SERVICE BULLETIN

No. 488

Piper Aircraft Corporation

Modification of Landing Gear Selector Cable Forward Attachment Pin.

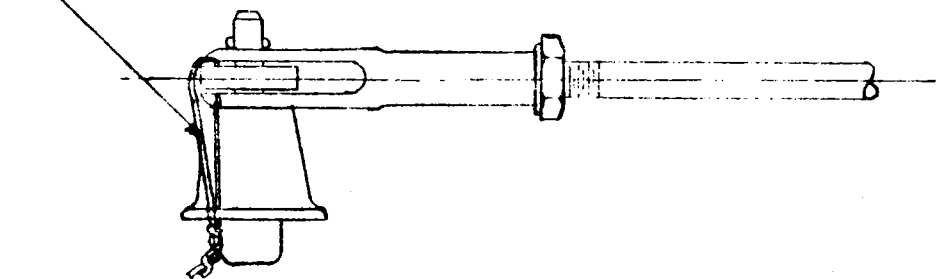
The landing gear selector flexible push-pull control cable assembly is attached to the hydraulic powerpack control arm by a cable attachment pin assembly, Piper part no. 53599-00. A recent incident at the factory indicates that this pin assembly may become disengaged, causing detachment of the landing gear selector cable from the powerpack control arm, with subsequent loss of landing gear (retraction/extension) system control.

This release provides instructions to install safety wire to the landing gear selector cable attachment pin to prevent inadvertent disengagement of the pin.

5. Safety with approximately three inches of MS20995C41 lock wire (.041 stainless steel) through the hole in the arm and existing hole in pin knob per attached sketch.

Wrap lock wire around arm on side opposite from cable, to prevent interference with cable clevis during normal operation.
